SERVICE BULLETIN

N° **139-684**

REV. : B - April 4, 2023

ATA 93 - TURRET FLIR UNIT REPLACEMENT

Figure 1

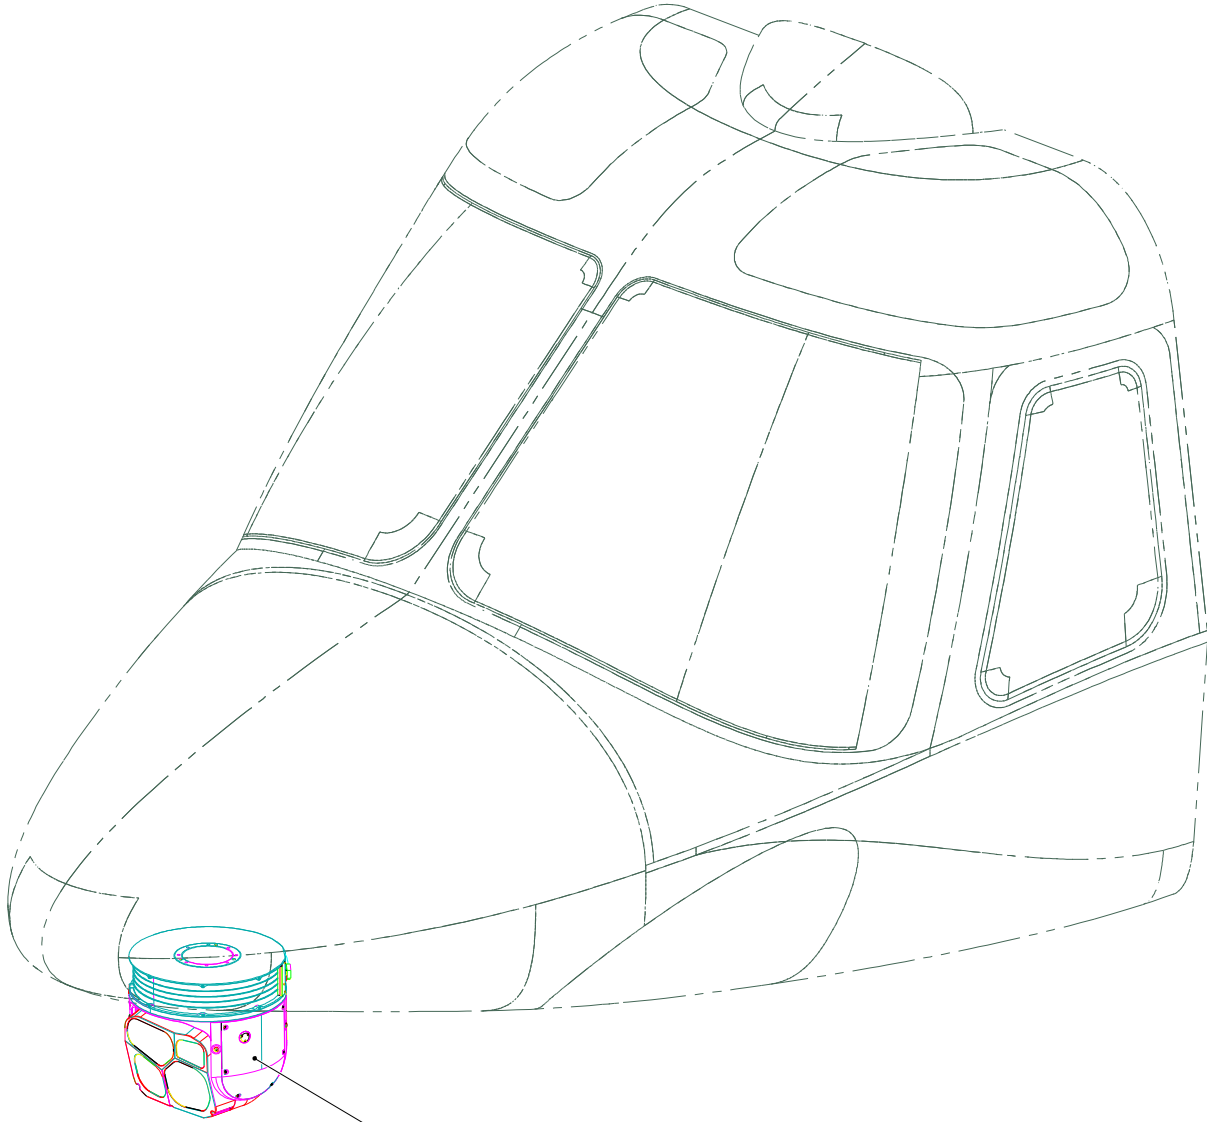
REMOVE:
3G9350101231 FLIR SS380 HDC TFU VENDOR CONTROL DRAWING
INSTALL:
3G9350102031 FLIR SS380 HDC TFU VENDOR CONTROL DRAWING
(USE EXISTING HARDWARE)

Figure 2

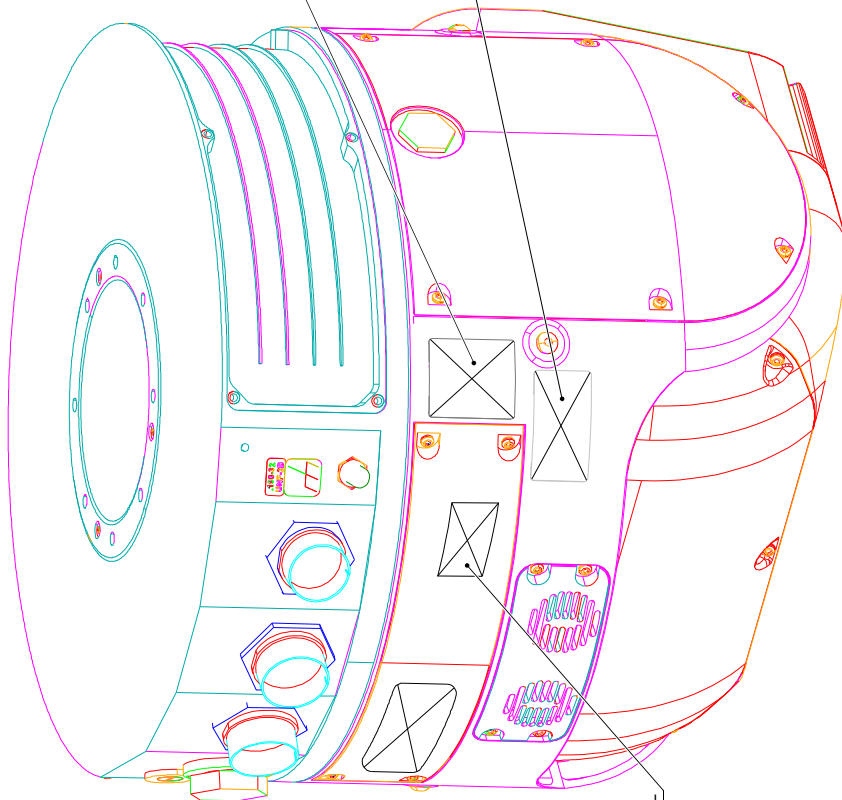
1. DURING THE INCOMING INSPECTION CHECK THE INSTALLATION OF THE TWO VENDOR IDENTIFICATION LABELS SHOWN BELOW:

2. AFTER INCOMING INSPECTION APPLY LABEL A016A004B1 AND MARK IT IAW NOTE 1.

1. MARK A016A004B1 IAW CSPP DM CSPP-A-60-80-03-A-691AC WITH AUGUSTWESTLAND P/N 3G8350102031 AND MANUFACTURER SERIAL NUMBER
